Attachment 3 - 51-55 Westbury Road and 27 and 29 Peel Street, South Launceston  
- Representations - (pages = 16)

Application DA0526/2016  
Address 51-55 Westbury Road South Launceston TAS 7249  
Description Residential - multiple dwellings; construction and use of four multiple dwellings  
Name of commenter Angela  
Address of commenter  
Email of commenter

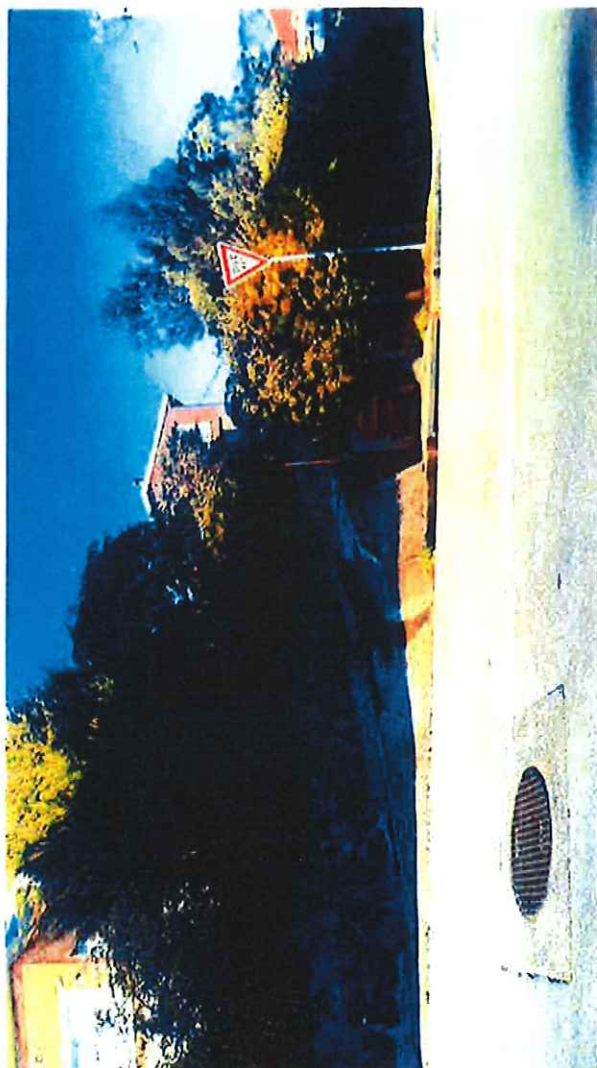
Dangerous entrance at Peel St

The tree to be remove with Neighbours looking directly into yard and back windows because of the proposed three blocks of flats stories.
